KDS IDR Ltd.

CDA Plot # 15 (P)+16, Mohora I/A, Chandgaon, Chittagong
(22.398815N, 91.865572E)
Survey Date: 11th March 2015

Observations

Column Schedule

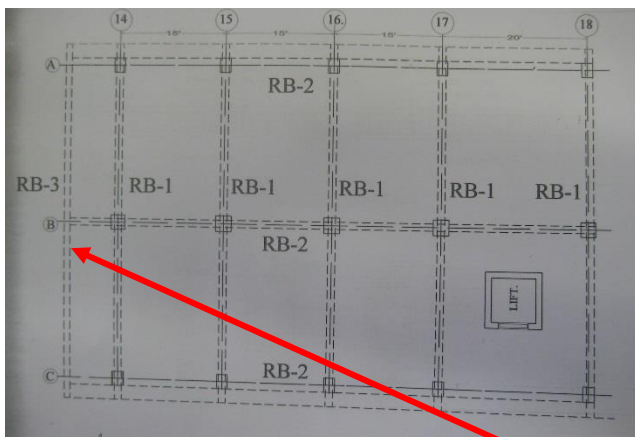
Internal column measured at 5th floor

Factory Building

As-built columns above 2nd floor not consistent with drawings

- Internal columns noted on drawings as 27" (685mm) square, but those above 2nd floor measure as 25" square with finishes - say 24" (610mm) without finishes. (Ground and 1st floor columns match the drawings)
- Number of bars in internal columns at all levels appeared to be less than shown on the drawings (based on Ferrosan and bars projecting from the columns at roof level)

Office Building

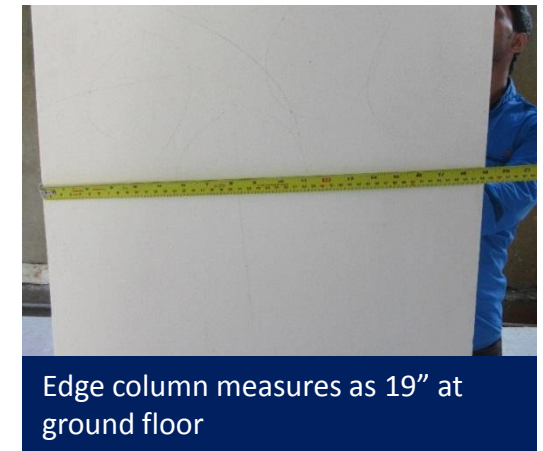
- Beams beyond column line are not present.
- Expansion joint is located 650mm off wall of factory. Drawing shows joint on line of wall.
- This section of the slab appears to cantilever from the factory. As there is a stair void on the other side of the wall, it will have no backspan.

As-built columns not consistent with drawings

- Edge columns noted on drawings as 24" x 22" (610mm x 560mm) but those measured on site at are 25" x 19" with finishes - say 24" x 18" (610mm x 455mm) without finishes (at all levels of the building)
- Beams shown on drawing adjacent to expansion joint are not present on upper floors.
- Expansion joint on upper floors is not built in position shown on the drawings.
- Expansion joint is not visible at mezzanine floor.
- Expansion joint has been rendered over and has cracked.
